STANDARD FIELD SERVICE BULLETIN

FSB Number	CHRAEFSB2018-3
Author	Tony Bryan
Date	01/12/2018
Subject	Moto X4 - Front Camera Focus Performance
Model Affected	XT1900-1-7 (All Models)
Level Of Repairs	Level 2

Figure 1.0 – Rear Housing Assembly Rev Marking

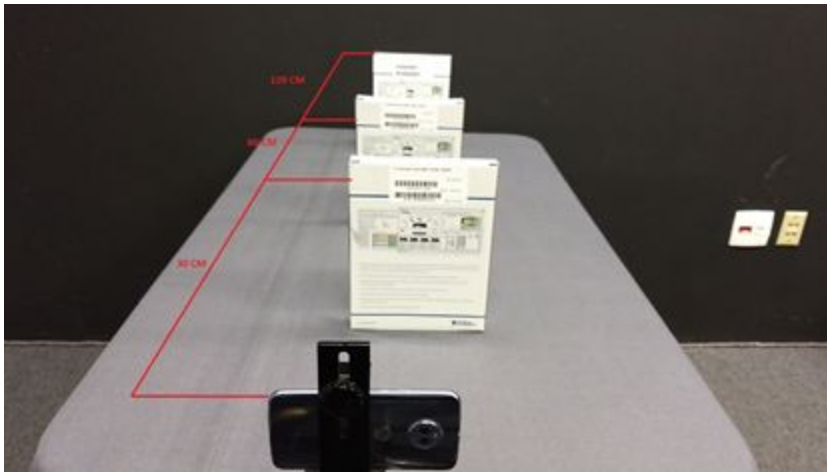
Any device confirmed to exhibit one of these two issues, using the provided Focus Test Procedure below, can be considered as problematic. Evaluation of problematic devices determined that although all individual components in the system were with-in specifications, the z-axis stack-up of the system as a whole may position the camera too close to the lens, resulting in a shift in focus range.

- A revision was made to the Rear Housing Assembly (P/N: 5S58C09xxx & SS58C19xxx) to add additional space for the Front Camera. Rear Housings Assemblies with this change can be identified with markings Rev B and later. See image below.

- i. Following Service Manual, carefully disassemble the device and remove PCBA from Rear Housing Assembly (P/N: 5S58C09xxx & SS58C19xxx).
 - ii. Inspect the Rev Marking on the Rear Housing Assembly (P/N: 5S58C09xxx & SS58C19xxx). If marking is Rev A, then replace Rear Housing Assembly (P/N: 5S58C09xxx & SS58C19xxx) with Rev B or later. Reference **Figure 1.0** above.
